## ADDENDUM #6

DCA Project No.: 22-136  
Project Name: York Region Warehouse Upgrades

**Addendum #:** E01

E-002

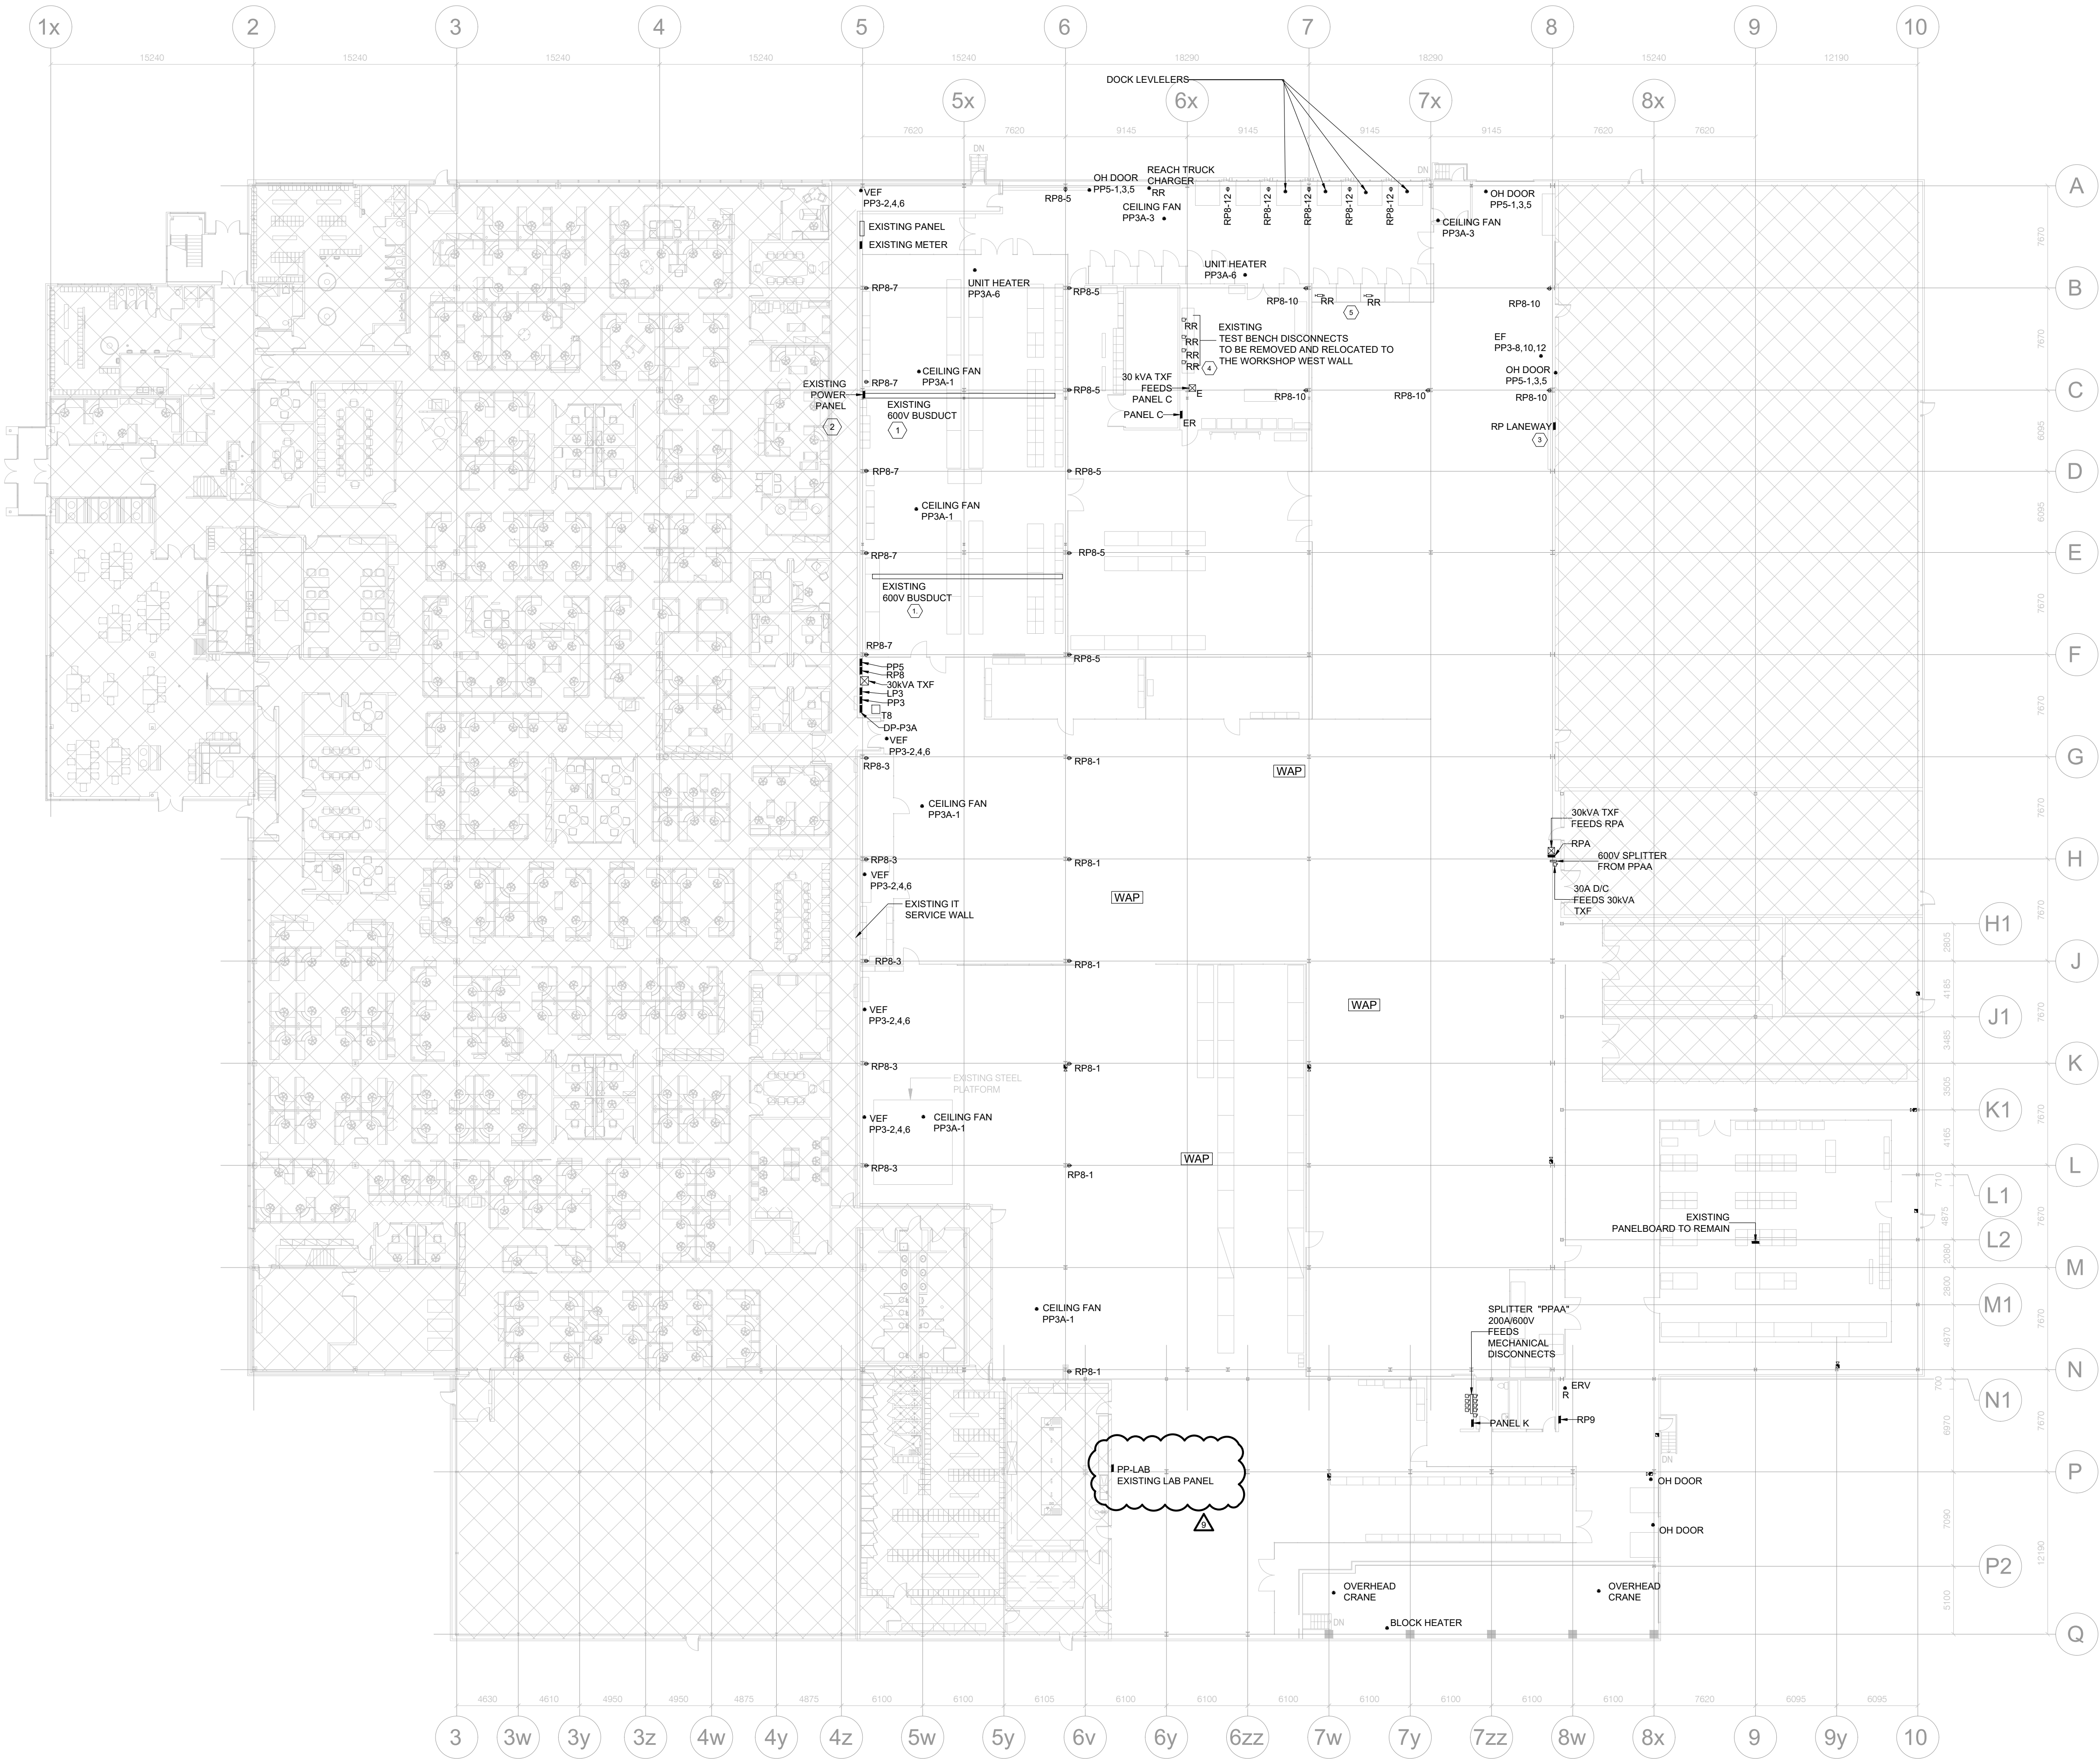
- .1 Drawing – E-002 – EV CHARGER SITE PLAN**
  - i) Refer to attached drawing for roof mounted conduits clarification.
  - ii) Refer to attached drawing for EV charger conduits clarifications.

- iii) Added sheet keynote 4.
- .2 Drawing- E- 101- EXISTING POWER & SYSTEMS PLAN – MAIN FLOOR**
  - i) The information has been revised and PP-LAB is existing and not new.

CONDUCTORS TO TRANSITION FROM UNDERGROUND TO EXTERIOR WALL AND RUN UP SURFACED TO ELECTRICAL ROOM LOCATED ON SECOND LEVEL. RE-USE EXISTING CONDUCTORS ROUTE IF POSSIBLE. REMOVE EXISTING SECONDARY CONDUCTORS AND REPLACE WITH NEW, RE-USE EXISTING CONDUCTOR ROUTING TO EXISTING MAIN SWITCHBOARD.

SCALE 1:150 DRAWING No. **E-102**

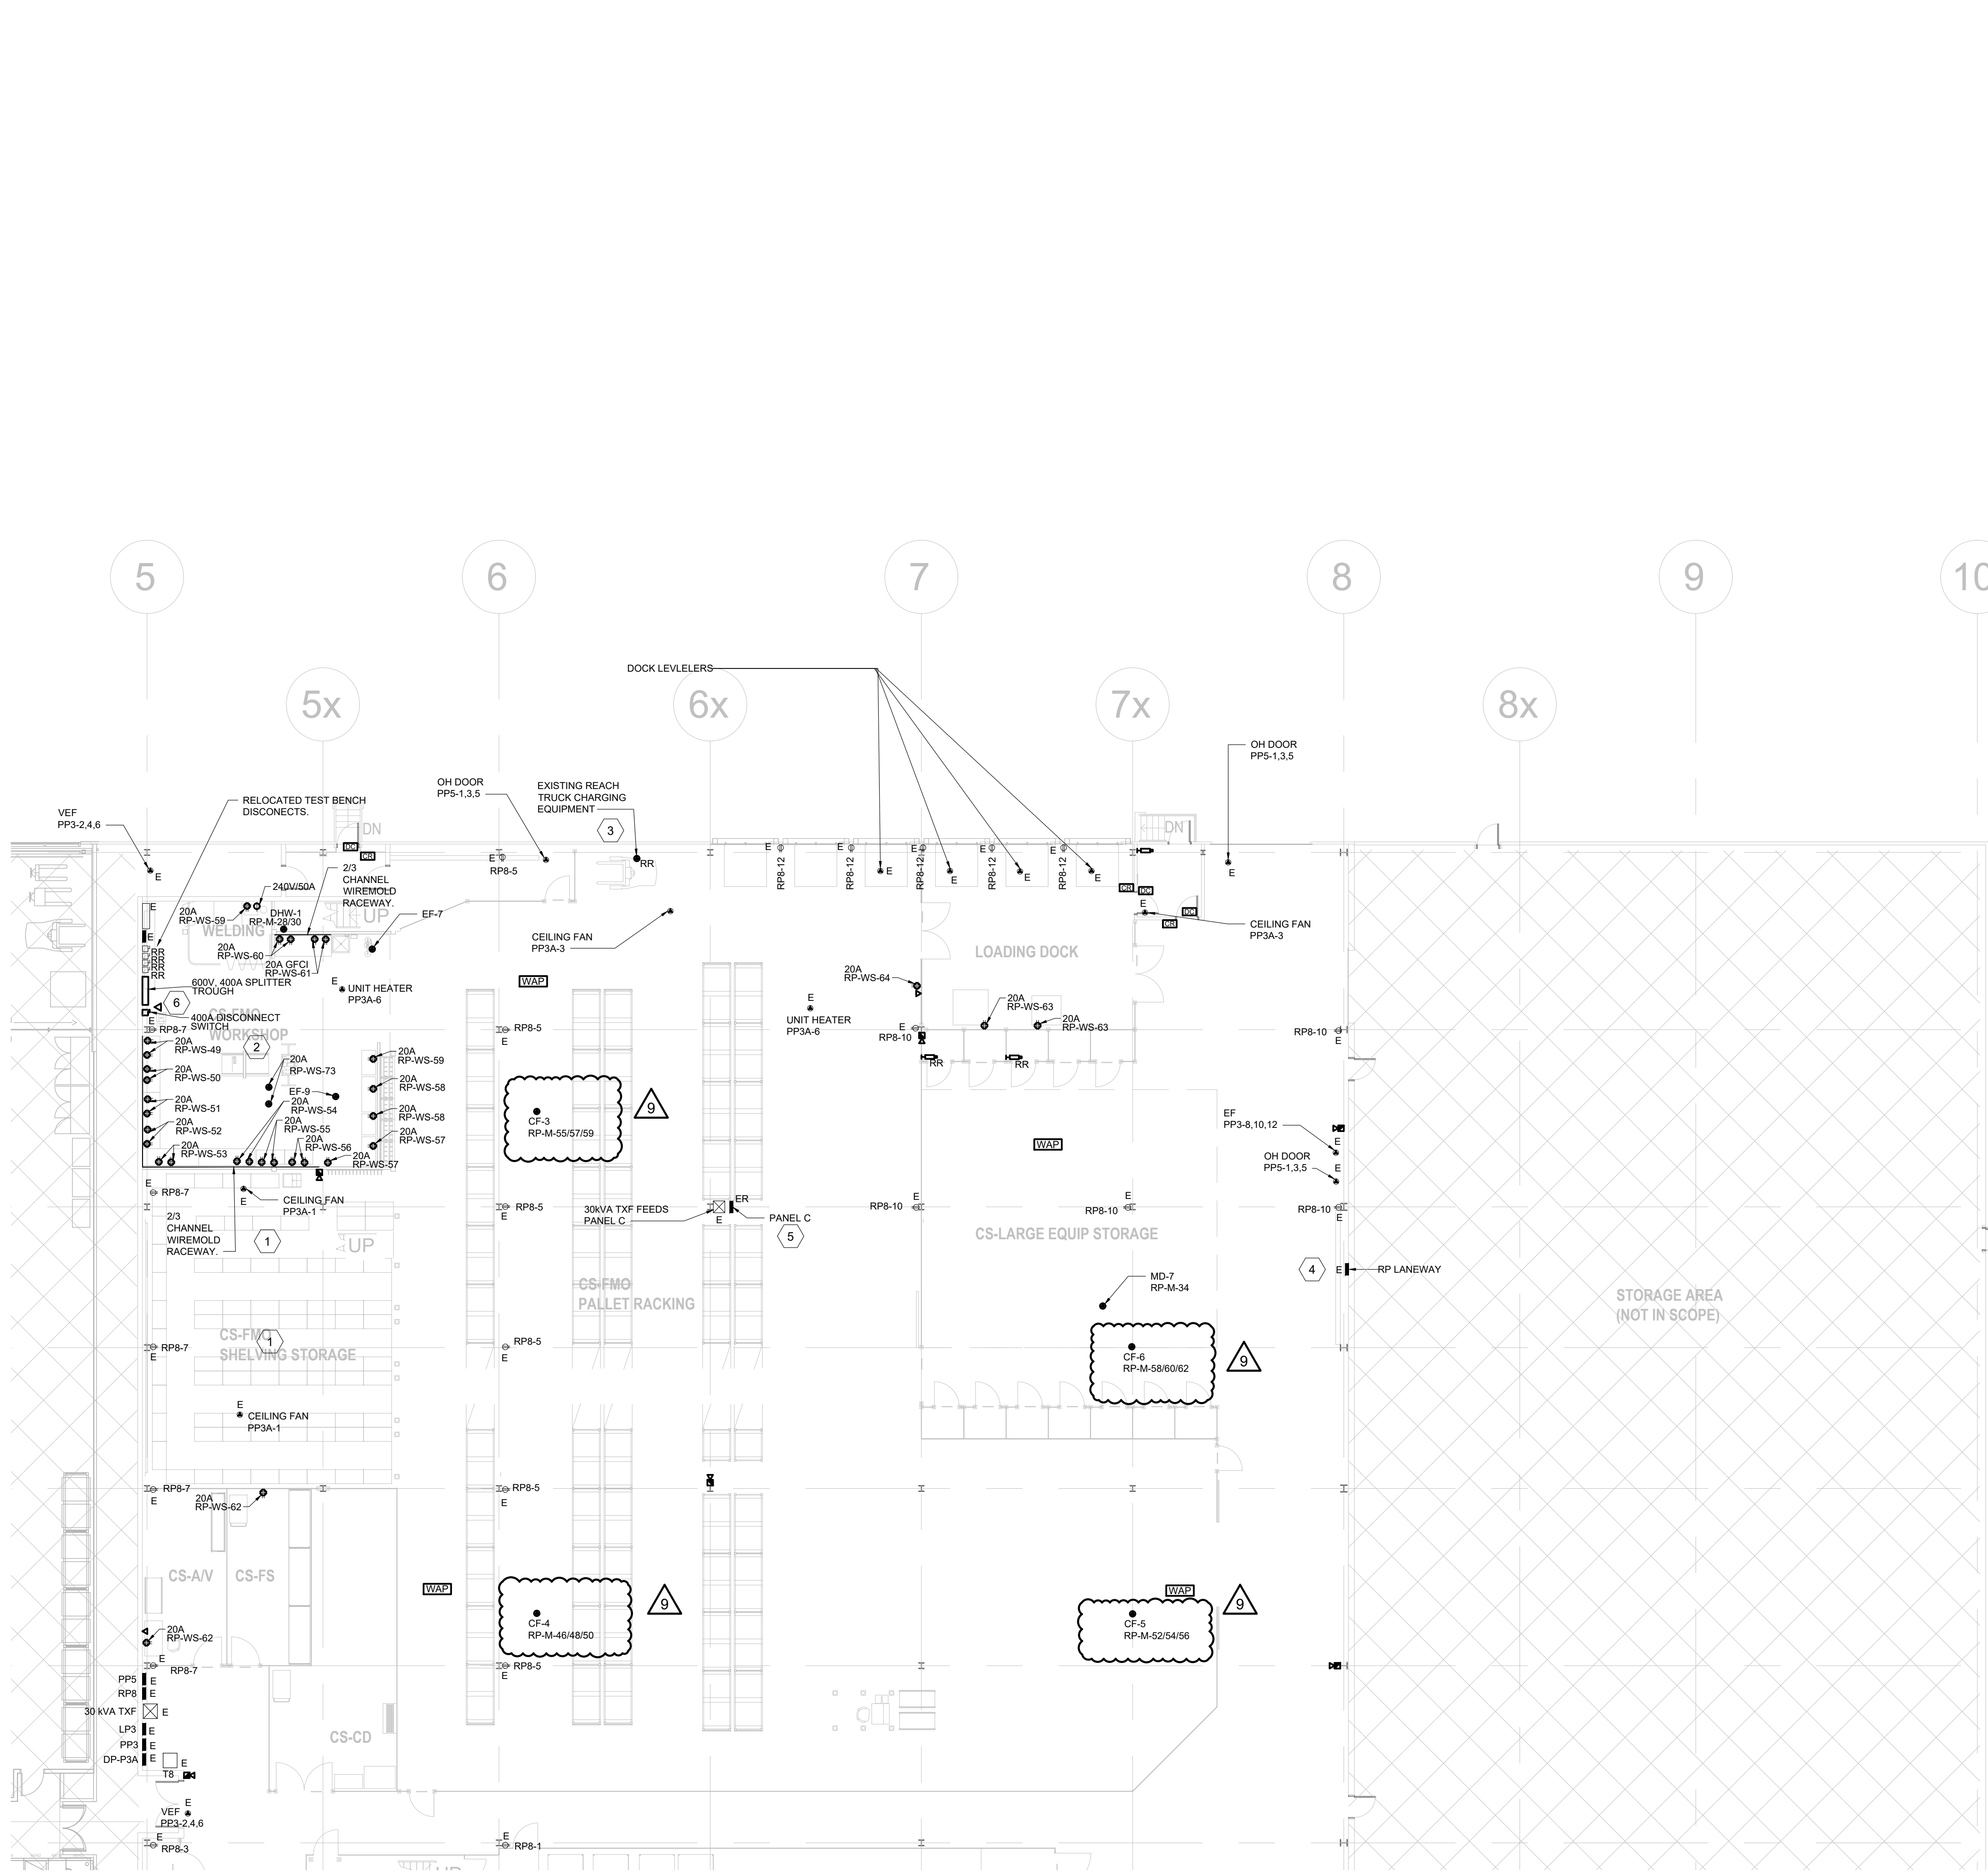
- .3 Drawing- E- 102- POWER & SYSTEMS – PUBLIC WORKS**
  - i) Refer to attached drawing general sheet notes for EV transformer scope of work clarification.

- ii) Added ceiling fans CF-1 and CF-2. Refer to sheet E-102 for specific locations.
- .4 Drawing- E- 104- POWER & SYSTEMS – Corporate Services**
  - i) Added ceiling fans CF-3, CF-4, CF-5 and CF-6. Refer to sheet E-104 for specific locations.

CHECKED TS	PROJECT No. <b>CM-22-149</b>
SCALE 1:150	DRAWING No. <b>E-104</b>

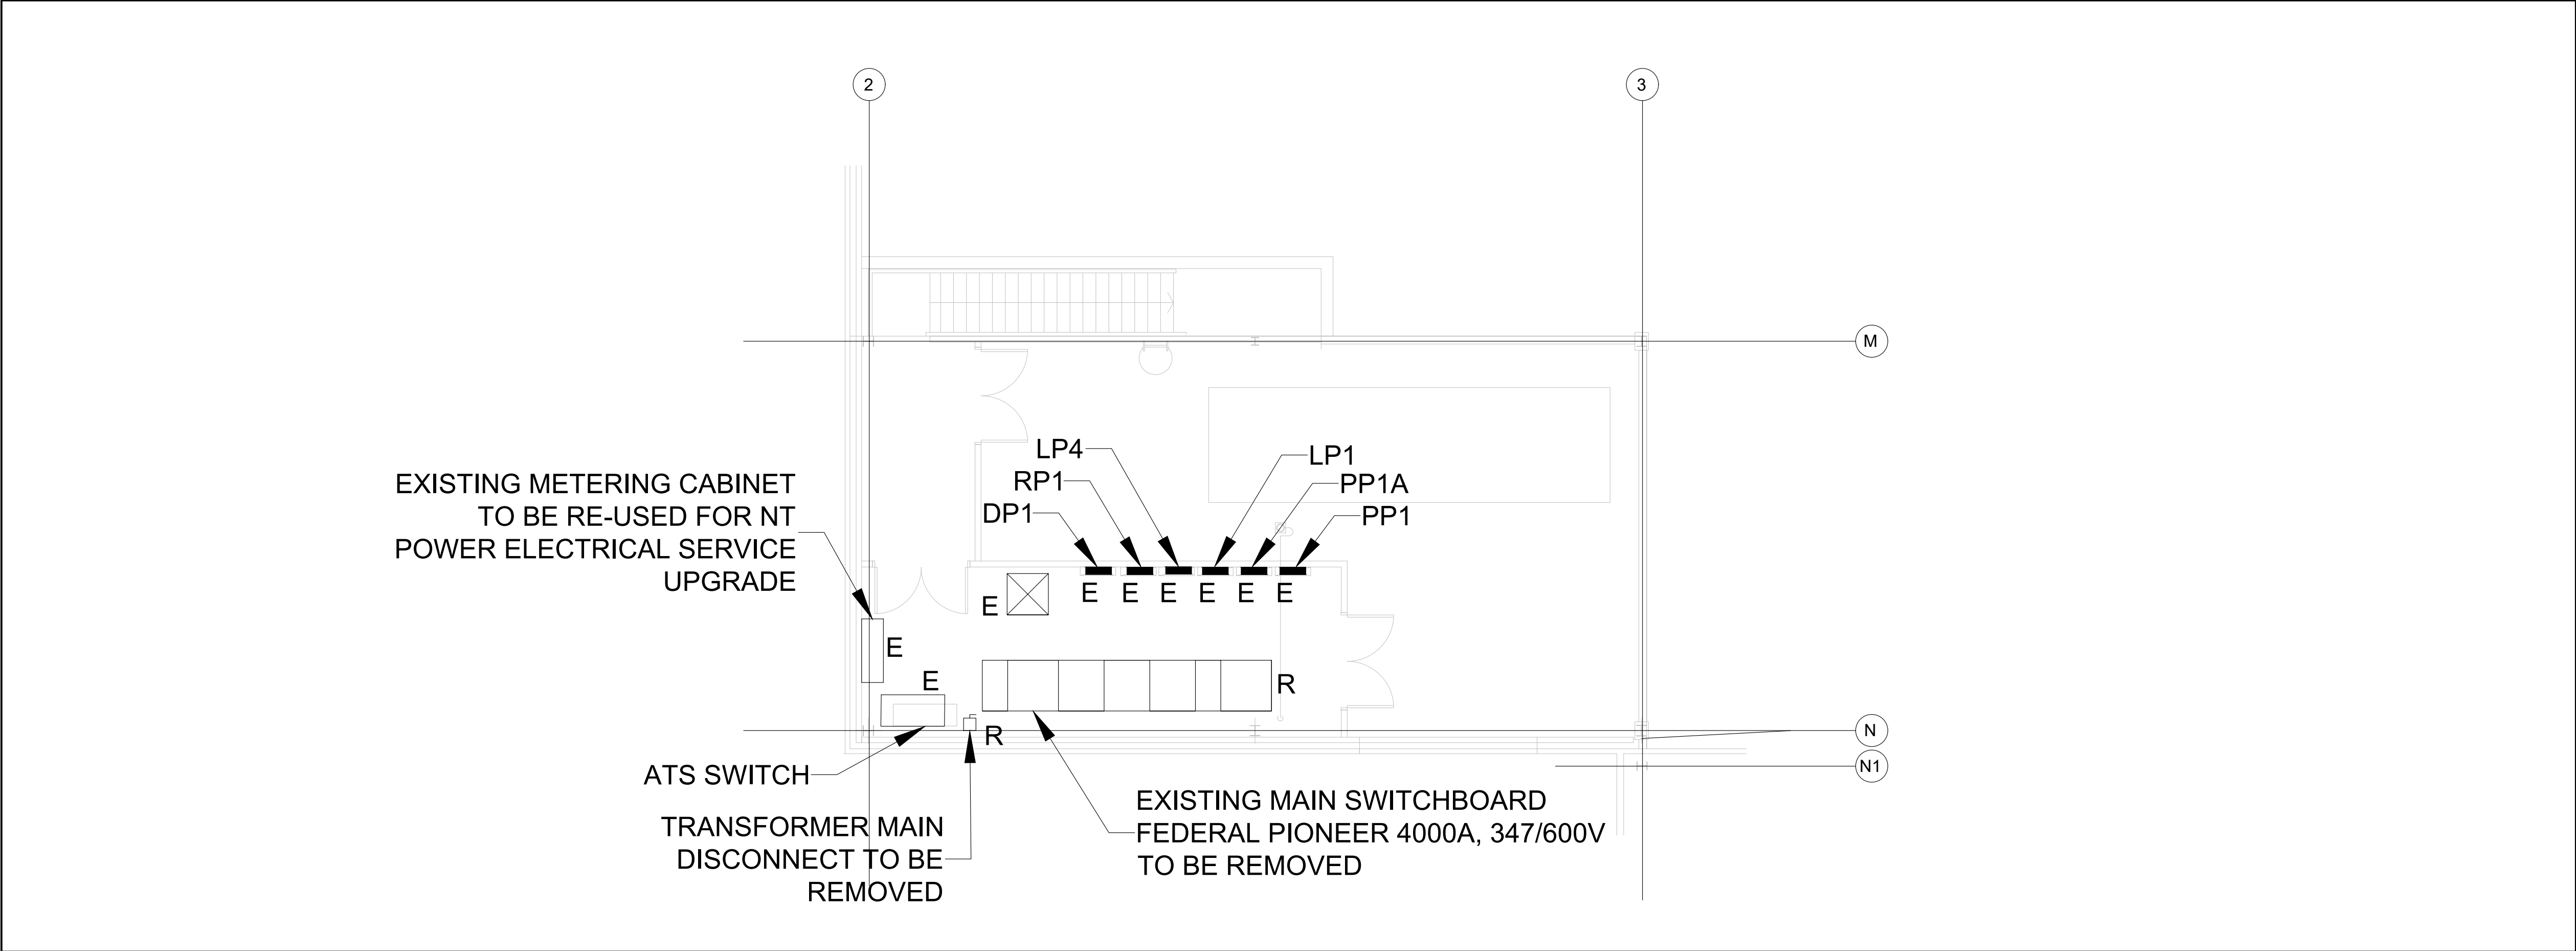
- .6 Drawing- E- 104- POWER & SYSTEMS – Corporate Services**
  - i) Information has been revised and scale to drawing has been added.
- .7 Drawing- E-201- PUBLIC WORKS NEW LIGHTING PLAN – MAIN FLOOR**
